ADDENDUM NO. 3

April 24, 2019

Ironhouse Sanitary District WRF Phase 1 Improvements
Project ISD-19-01
450 Walnut Meadows Drive
Oakley, California 94561

15300

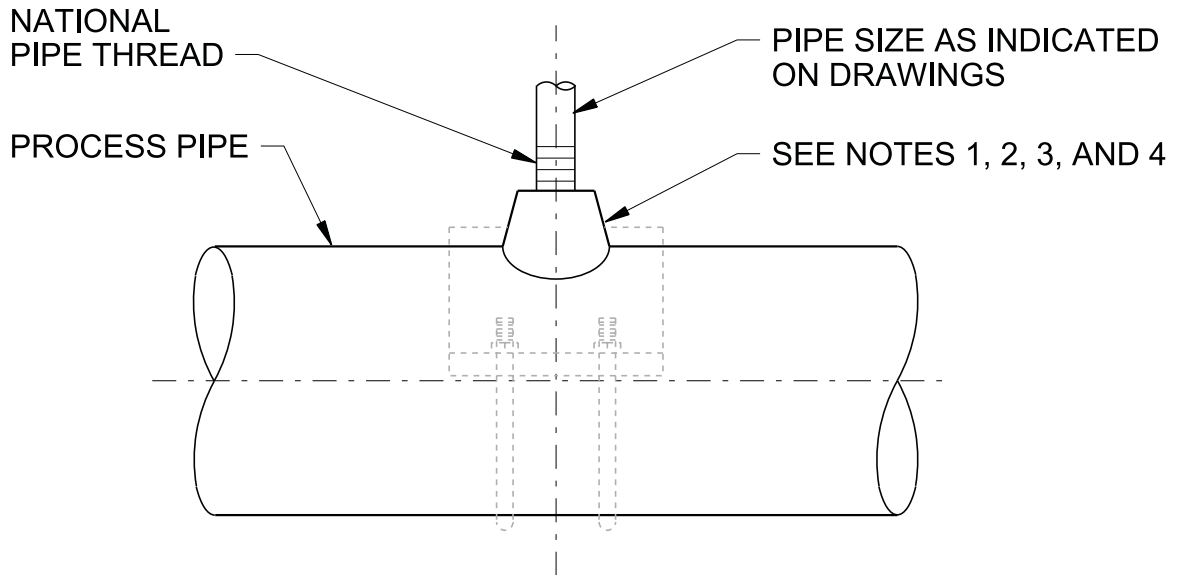
2. Standard Detail 15300 was missing from the Standard Detail (SD) drawings. Standard Detail 15300 is attached.
3. **Specification Section 01630 – OWNER-FURNISHED EQUIPMENT**: An additional Attachment E is hereby added to this Specification Section. Attachment E is an initial construction schedule for the original equipment manufacturer (OEM) of the headworks screening equipment, Parkson, to complete the work described in Section 01630, including activities to be completed by the OWNER and CONTRACTOR as defined in Section 01630. The following additional Coordination Requirements are added to Specification Section 01630 as Sub-Section 3.4.
